To: Bassett Creek Watershed Management Commission
From: Barr Engineering Co.
Subject: Item 4F – Three Rivers Park District Bassett Creek Regional Trail– New Hope
BCWMC March 17, 2016 Meeting Agenda
Date: March 9, 2016
Project: 23270051 2016 2070

4F Three Rivers Park District Bassett Creek Regional Trail – Crystal/New Hope

Recommendation: Conditional approval

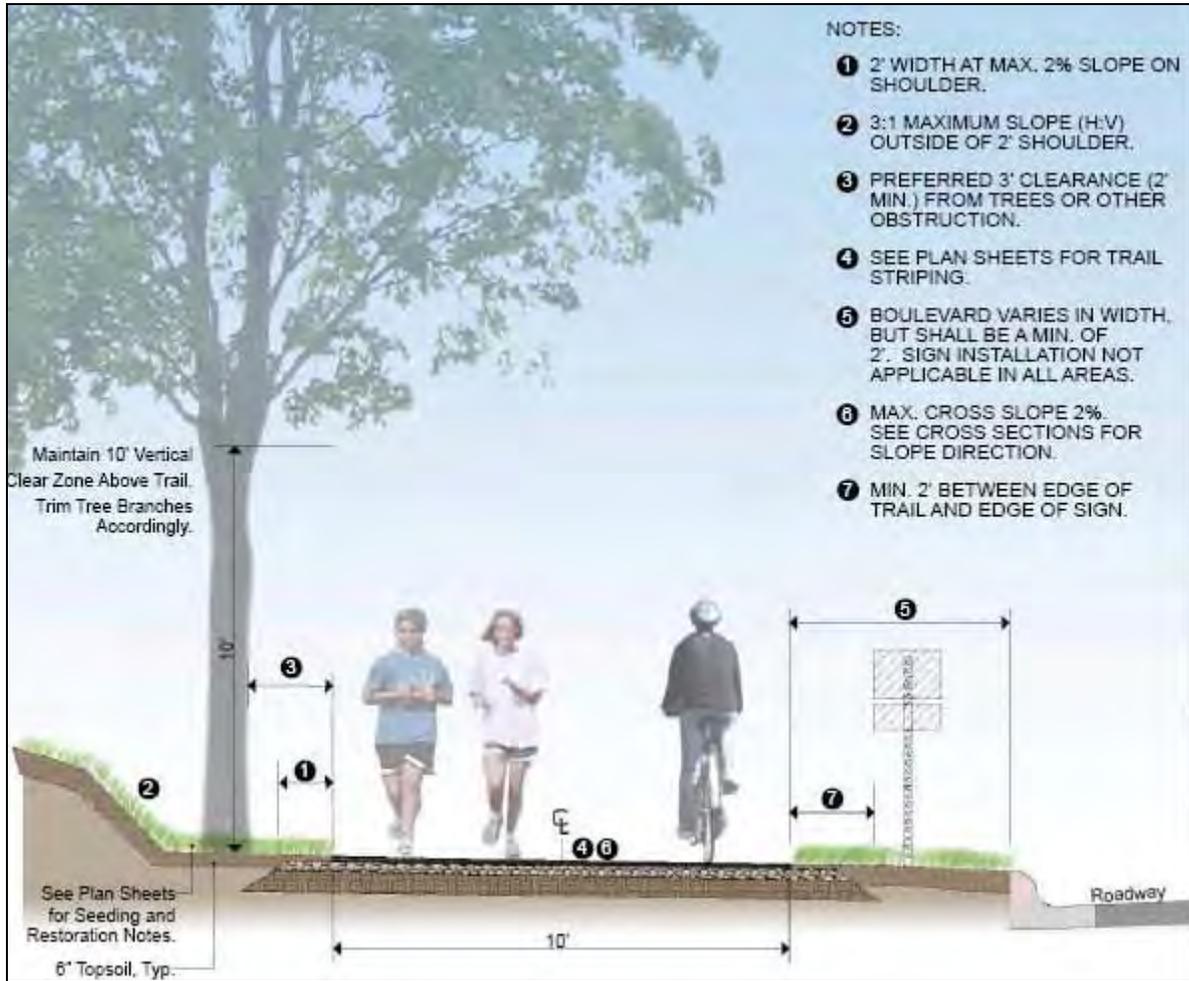
- a. **Water Quality:** The Plan does not indicate the proposed increase in impervious surface along the trail corridor. The Plan states:

Bassett Creek trail development is not anticipated to negatively effect Bassett Creek as best management practices will be followed during regional trail construction and maintenance activities, including erosion control measures and vegetation establishment as required.

However, since specific water quality features were not addressed, it appears this statement is related more to construction issues then to increased impervious surface. Under the current *Requirements for Improvements and Development Proposals Document (Requirements Document)*, this project would be reviewed as a road (linear) project. Paragraph 4.6 of the Requirements Document state:

The BCWMC should discuss whether to prepare comments based on its current standards or on anticipated standards that may be required during development of the project. The BCWMC should also discuss impacts of TMDL studies for Medicine Lake, Sweeney Lake, and Wirth Lake. At a minimum the following comments are suggested:

- The Plan should include proposed increases in impervious surface along each trail segment and discuss best management practices to address water quality.

- The Commission urges TRPD to incorporate infiltration and filtration measures, as feasible, along the trail. Maximizing the boulevard width to disconnect the trail from the street is recommended to reduce water quality impacts.
